**ULTRA  
TECHNOLOGY  
INCORPORATED**

Re: Requested Amendments to License No. 50-23363-01

The attached material contains two copies of revised pages to the Ultra Technology Inc. Safety Manual (Revision 1). The revisions are marked with side bars. It was necessary to modify our organizational structure slightly in complying with your requirements; a new chart is included for insertion in your copies of our Operations Manual. Replacement Index pages are included also because of an error. The first six pages of Attachment-E are to be replaced. Attachment-H is to be replaced entirely.

## ORGANIZATIONAL STRUCTURE

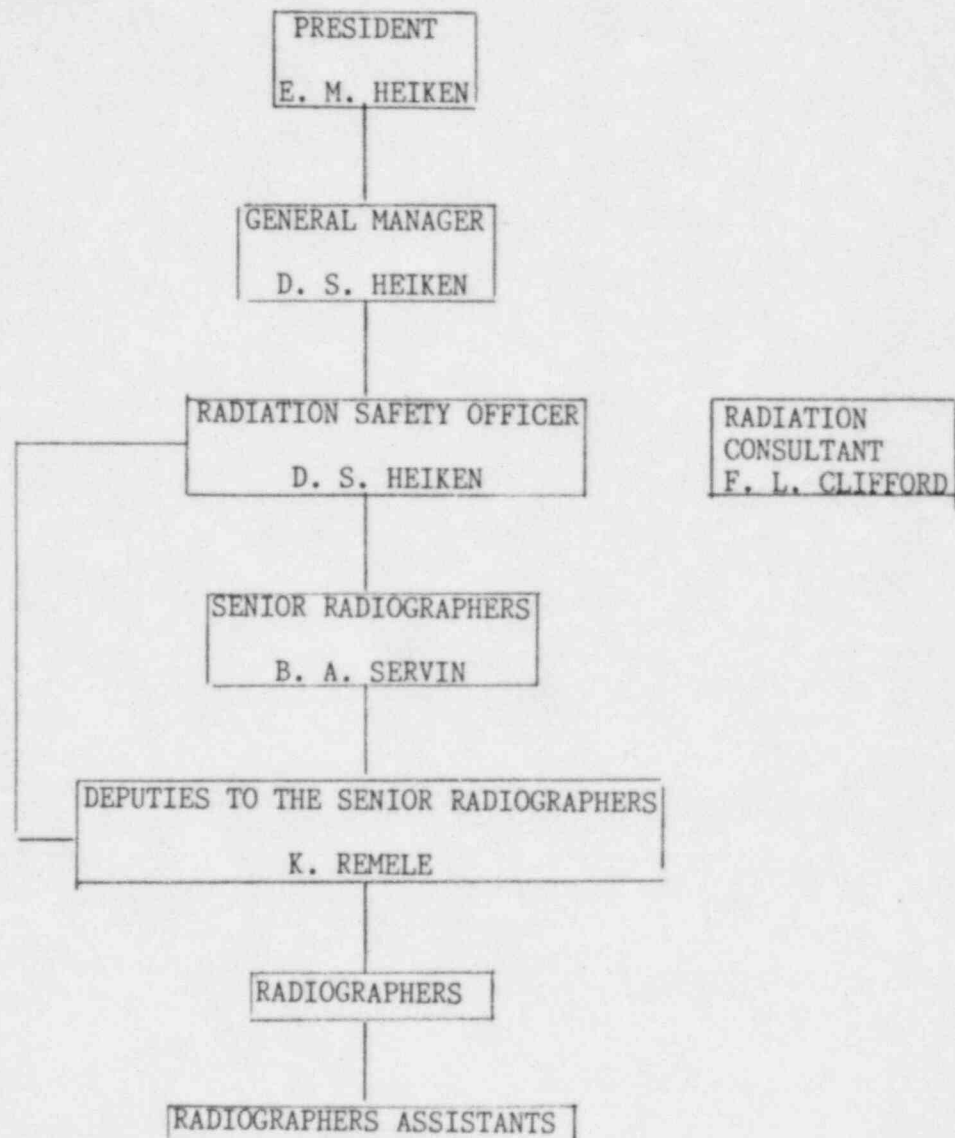
Attachment-H, page 5 has been revised and introduces 'Deputies to the Senior Radiographers'. With the addition of this position to our management structure this page creates a control structure which should assure NRC that experienced people are in control of the radiography operation but allows management to replace either individual for whatever reason timely. Further, we are undertaking to make replacements with individuals who are adequately trained, have the proper attitude and have a minimum of one years experience with sources. Pages 7 and 8 follow through and appoint the individuals with resumes or other data following.
